Response to

Request for Additional Information No. 12, Revision 0

U. S. EPR Standard Design Certification

Docket No. 52-020

Figure 2.3.3-1—Severe Accident Heat Removal System Functional Arrangement

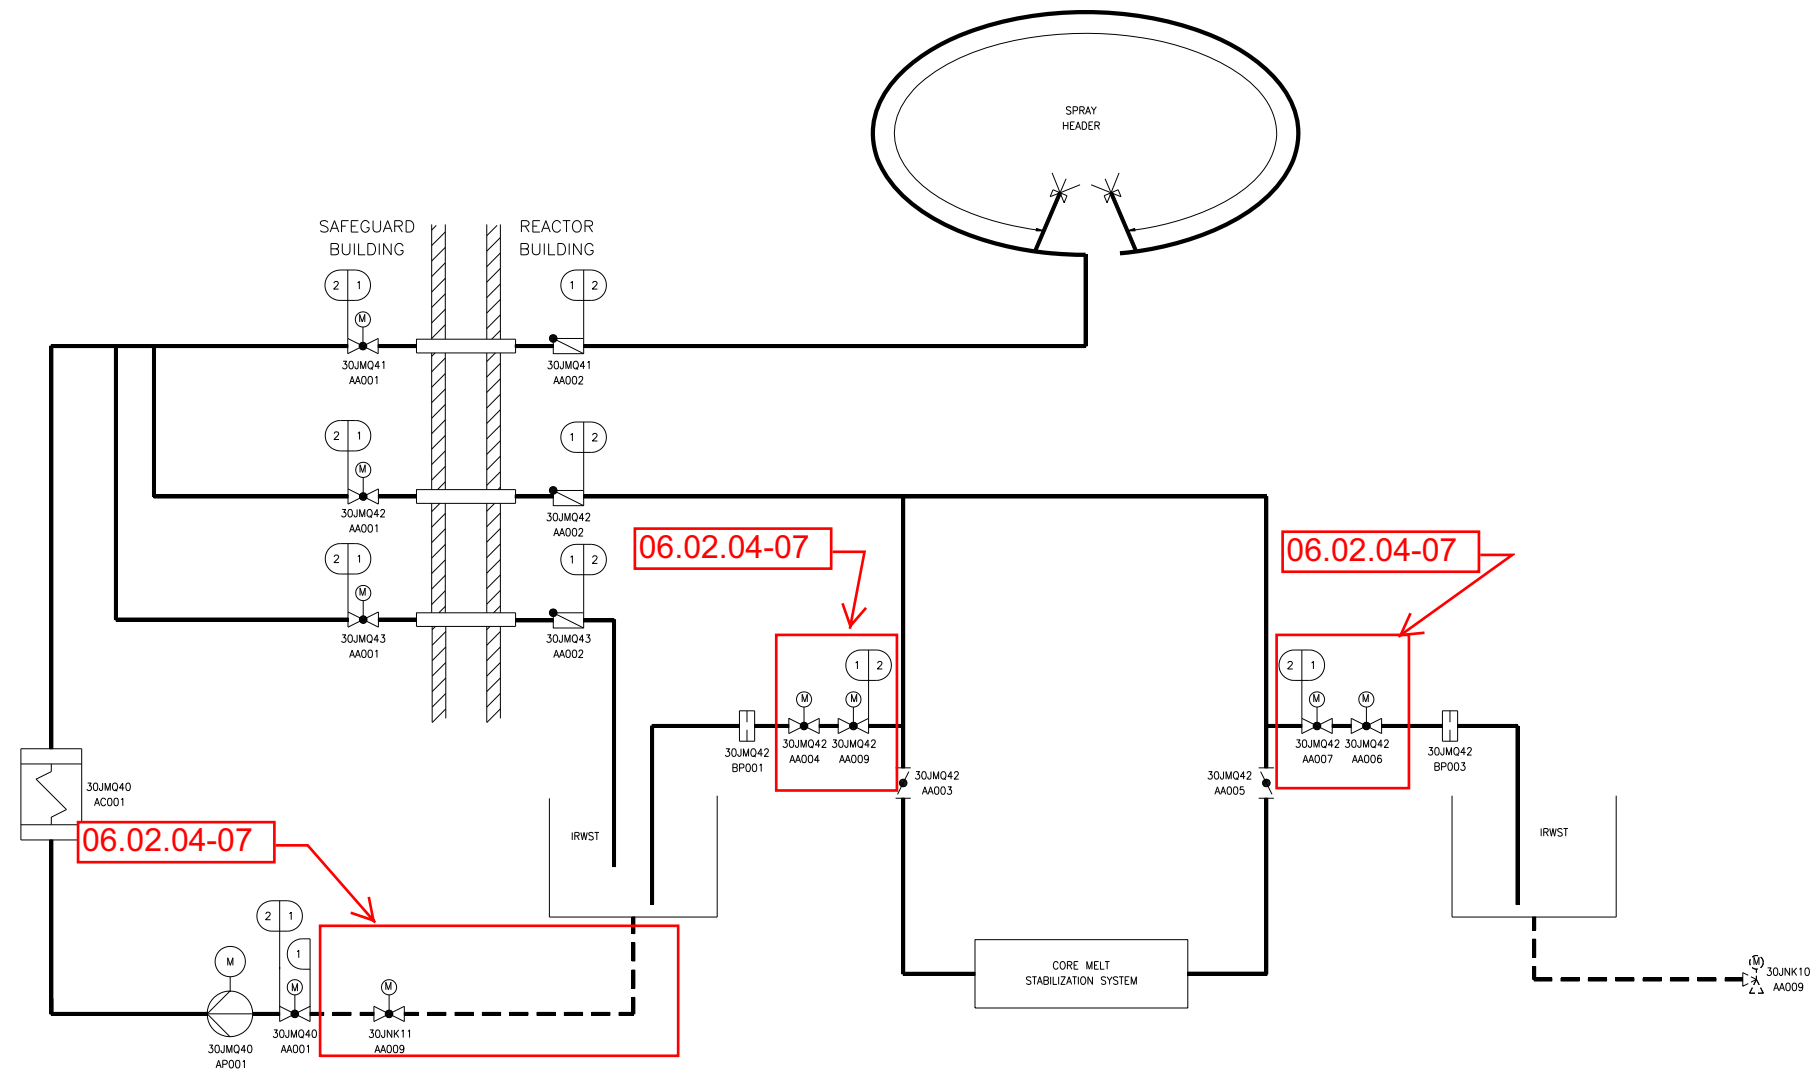
7. The class of piping represented on FSAR, Tier 1, Figure 2.3.3-1 shows the piping from the IRWST is Class 1 not the T-connection. The piping from the IRWST through devices JMQ42BP001 and JMQ42BP003 is classified a Class 1 to preclude the possibility of obstruction of the IRWST water to the Safety Injection function or potentially draining IRWST water to the spreading area. FSAR, Tier 1, Figure 2.3.3-1 will be modified to add two isolation valves and to place the class break on the lines at the second isolation valve from the IRWST as shown in the enclosed FSAR markup.

8. FSAR, Tier 1, Figure 2.3.3-1 is not correct. FSAR, Tier 1, Figure 2.2.2-1 is correct. Figure 2.3.3-1 will be modified to indicate the representation for the 30JNK11AA009 as a motor operated valve as shown in the enclosed FSAR markup.

Figure 3.5-1—Representative Containment Isolation Valve Arrangement

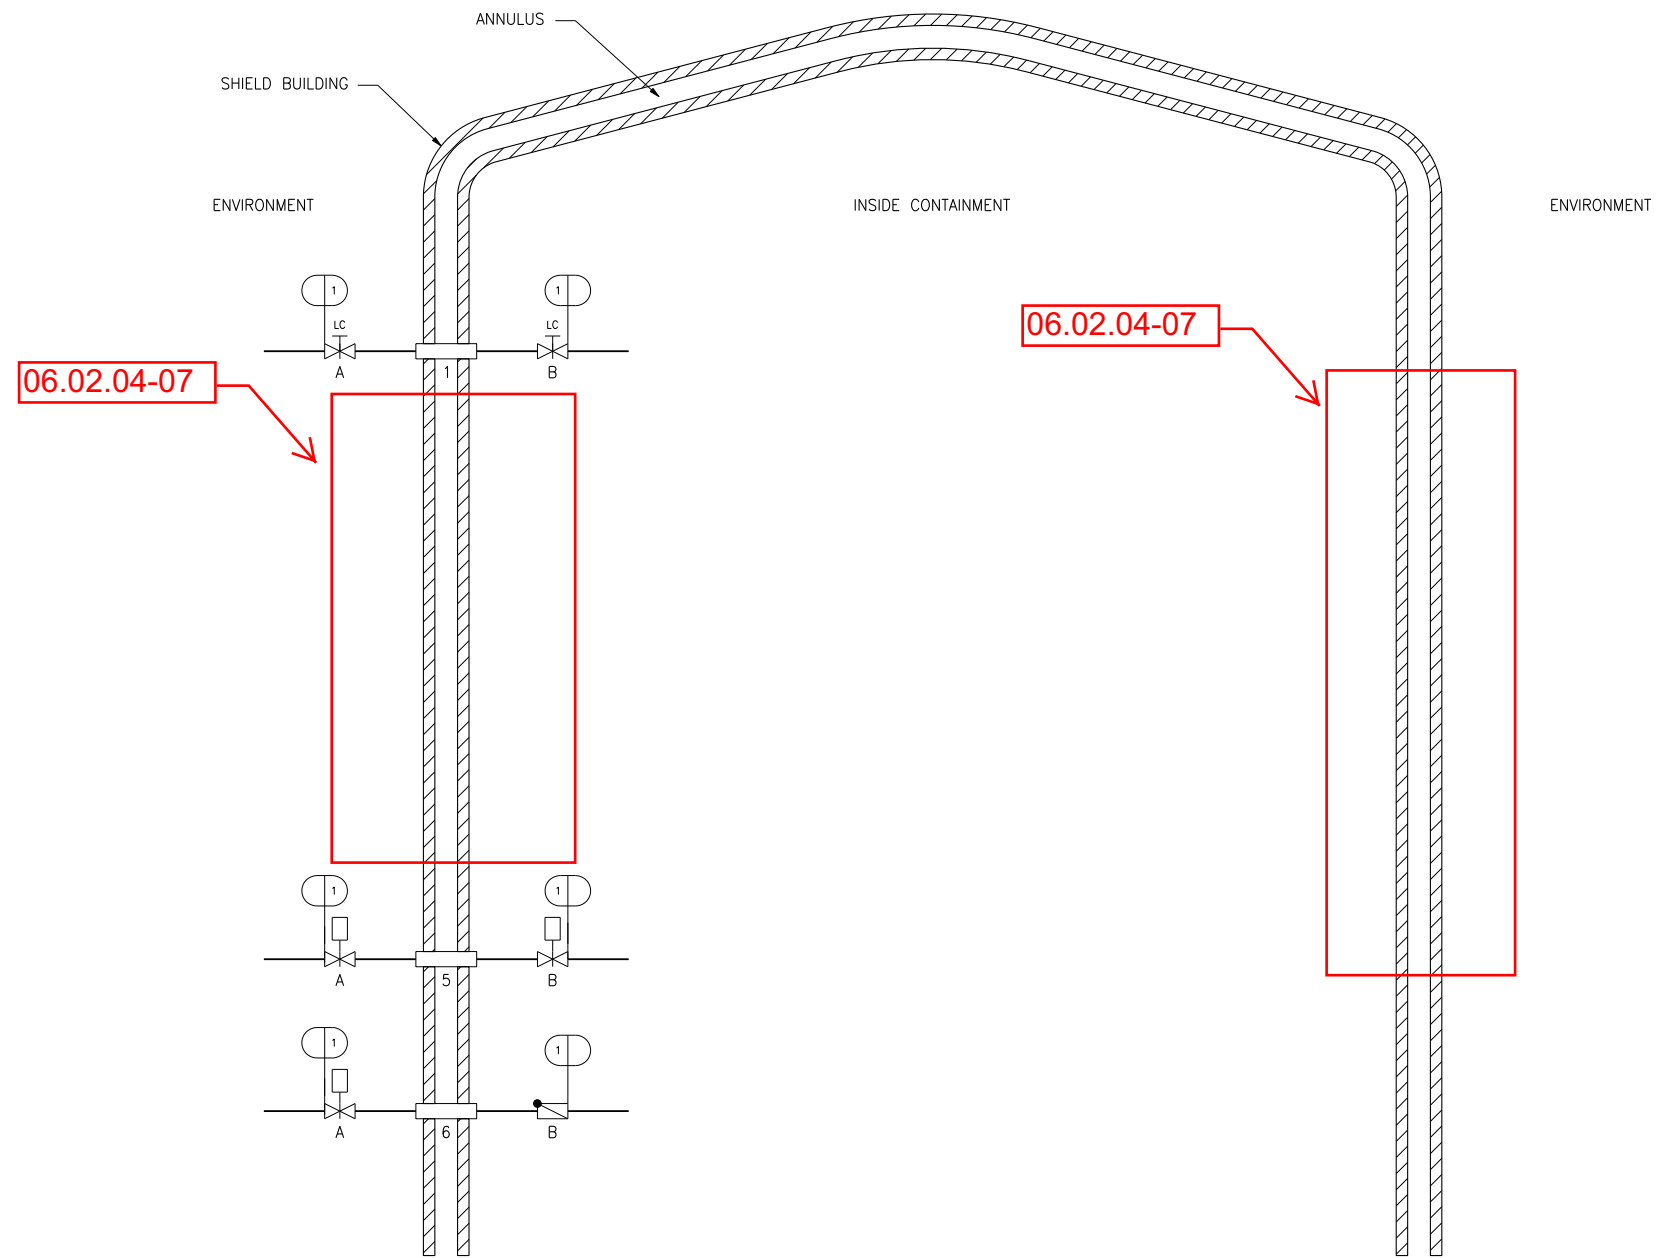
5. Configuration type 2, 3, 4, 7 and 8 arrangements are not required for FSAR, Tier 1, Section 3.5 and will be deleted from Figure 3.5-1 as shown in the enclosed FSAR markup.
